*Private Fuel Storage, L.L.C.*

June 15, 1998

**SUPPLEMENTAL RESPONSE TO RAIs  
PRIVATE FUEL STORAGE FACILITY  
DOCKET NO. 72-22 / TAC NO. L22462  
PRIVATE FUEL STORAGE L.L.C.**

REQUEST FOR ADDITIONAL INFORMATION NO. 1  
QUESTION 2-3  
WATER WELLS WITHIN 5 MILES (8 KM)  
OF PFSF SITE  
PRIVATE FUEL STORAGE FACILITY

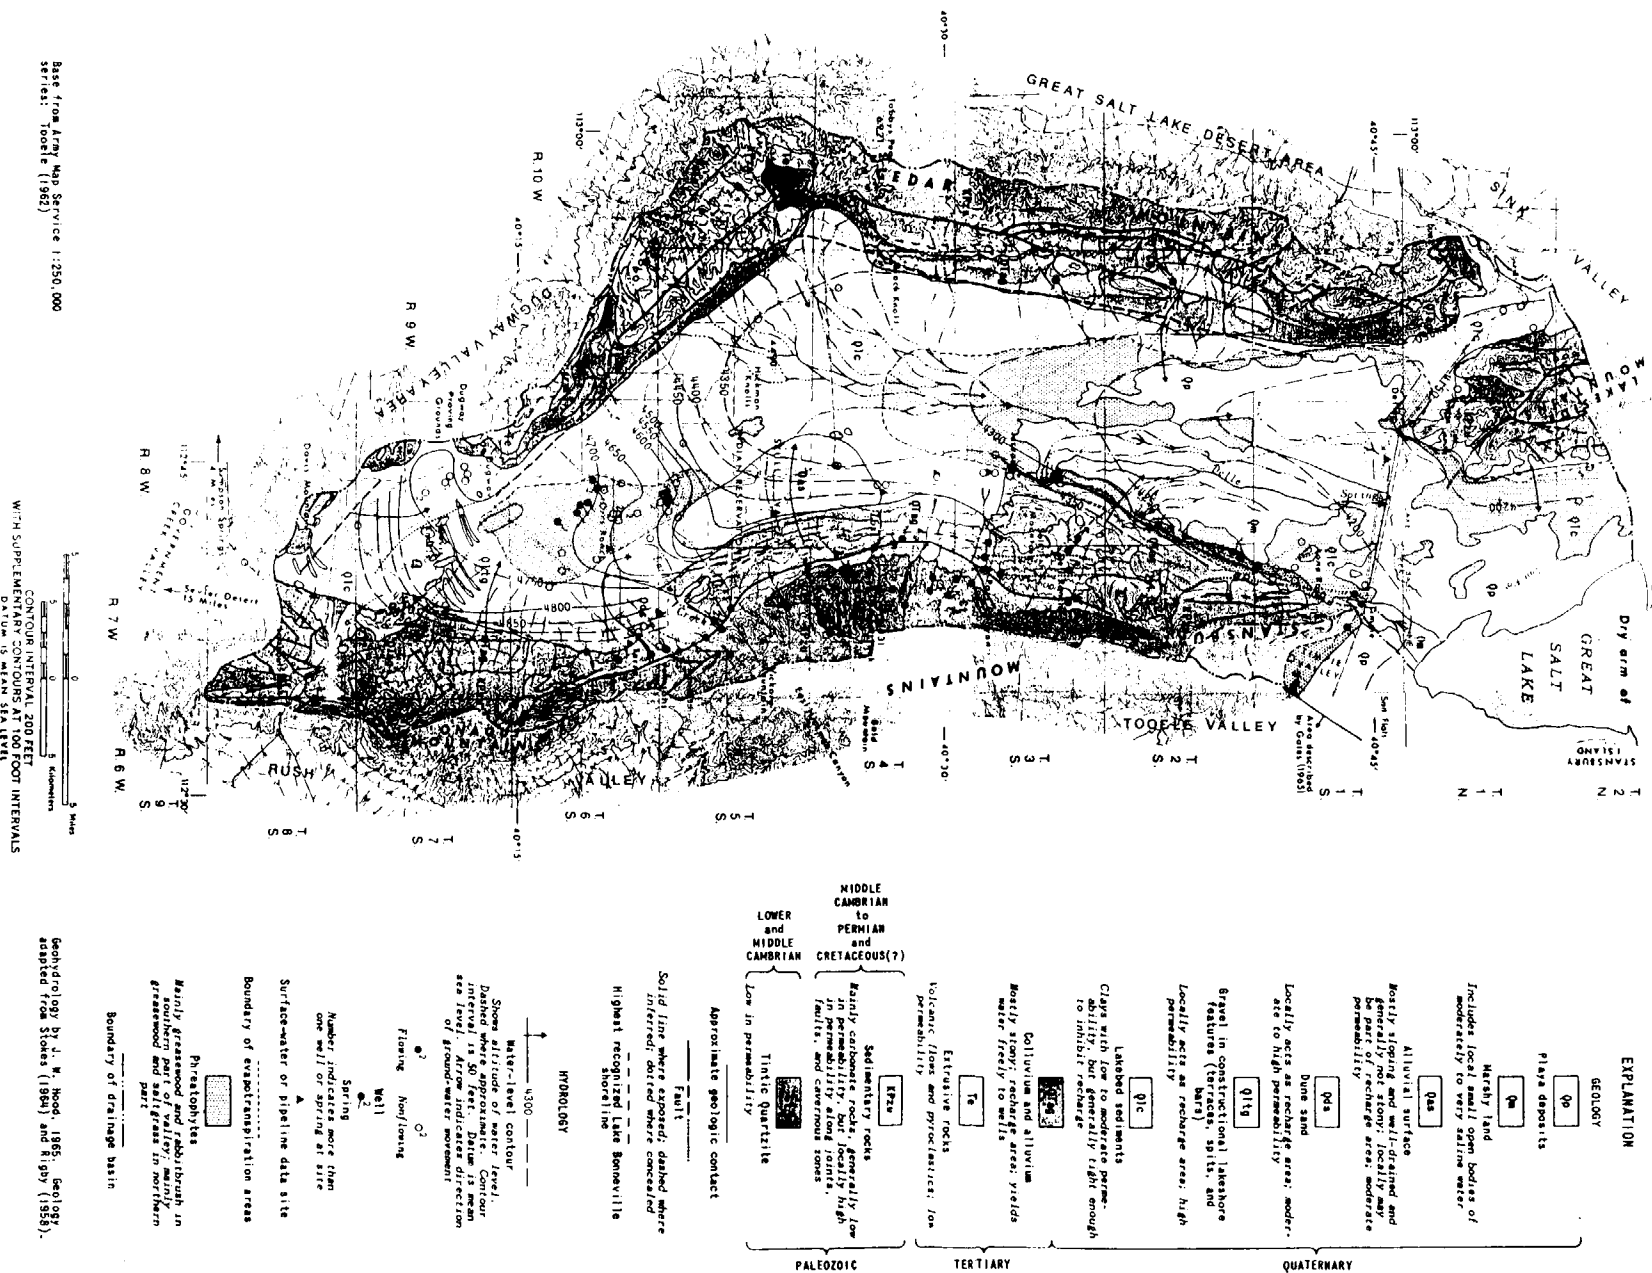
- 2-3 Provide the following information relative to the withdrawal and use of water on or near the proposed Private Fuel Storage Facility (PFSF):
- (a) A map that shows where water withdrawal is occurring on or in the vicinity of the PFSF site with particular reference to the proposed storage pad. At the least, include all wells located within a minimum 8-km (5 mi) radius of the PFSF.

- (b) For each identified well-
    - Depth to water
    - Formation from which water is withdrawn
    - Quantity of water withdrawn annually and pumping rates

- Discussion of use of the water from each well with particular reference to any consumption by humans or animals
  - (c) If no water wells are located within the specified 8-km radius of the proposed PFSF site, include a specific statement such as "No groundwater is extracted within the 8-km (5 mi) radius of the proposed PFSF."

- (a) The enclosed figure indicates the locations of all known water wells within 5 miles (8 km) of the PFSF. Other off-Reservation wells may have been drilled within five miles of the PFSF but they do not have a current water right on-file with the State's Division of Water Rights. Some of the wells in the table appear to be abandoned or have not been utilized in many years, such as the wells to the west and south of the Reservation, but the water right has been maintained.
- (b) The enclosed figure includes a table listing the requested information, where available. No crops for human consumption are grown with water from irrigation wells listed in the table.

- (c) See response to (a), above.
- (d) The potentiometric map (Plate 1) from Hood and Waddell is included as part of this response.
- (e) The State has not applied an aquifer classification system to the aquifer in Skull Valley. A water quality map (Plate 2) from Hood and Waddell is included as part of this response.

Plate 1. — GENERALIZED GEOHYDROLOGIC MAP OF SKULL VALLEY, TOOELE COUNTY, UTAH

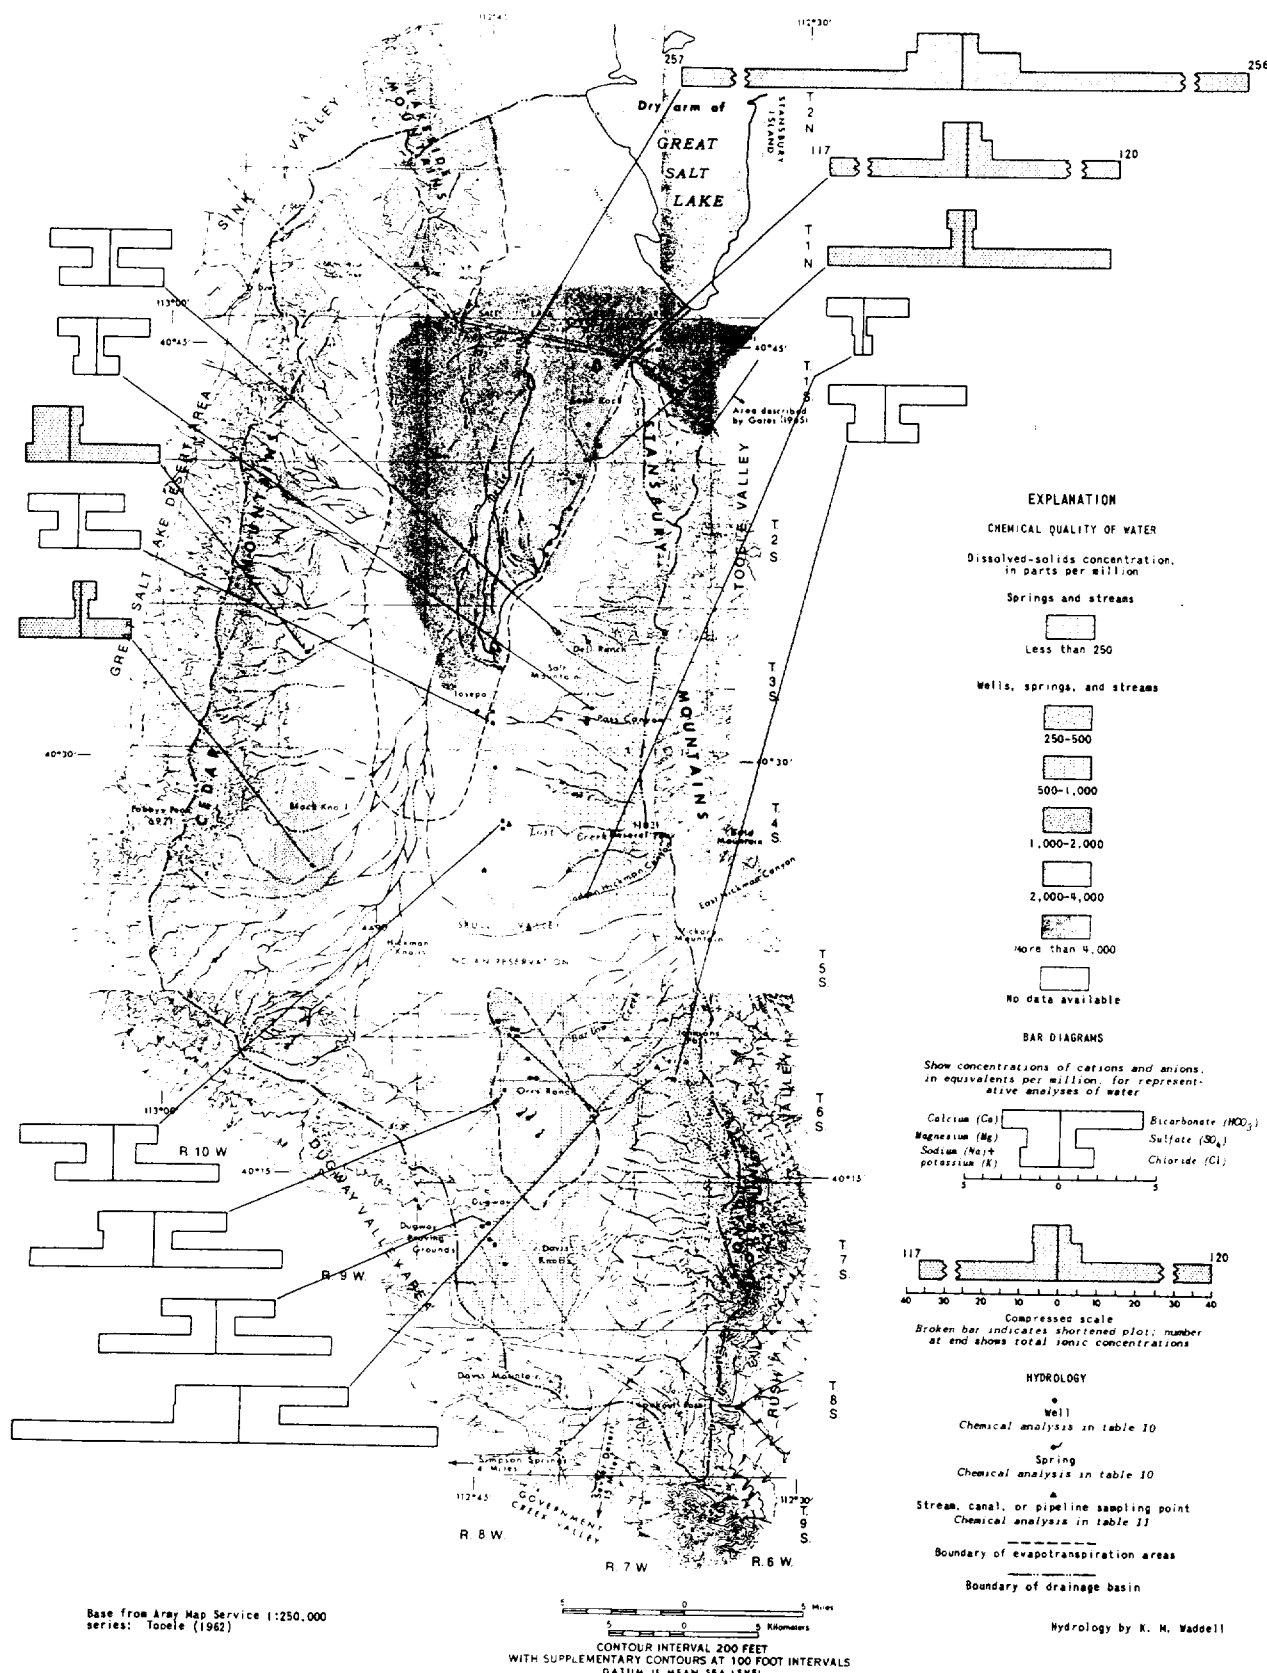
- (d) Potentiometric contours of groundwater at and around the proposed PFSF site (if relevant).
  - (e) Classification of the aquifer beneath the PFSF site based on class of use and water quality (if relevant).
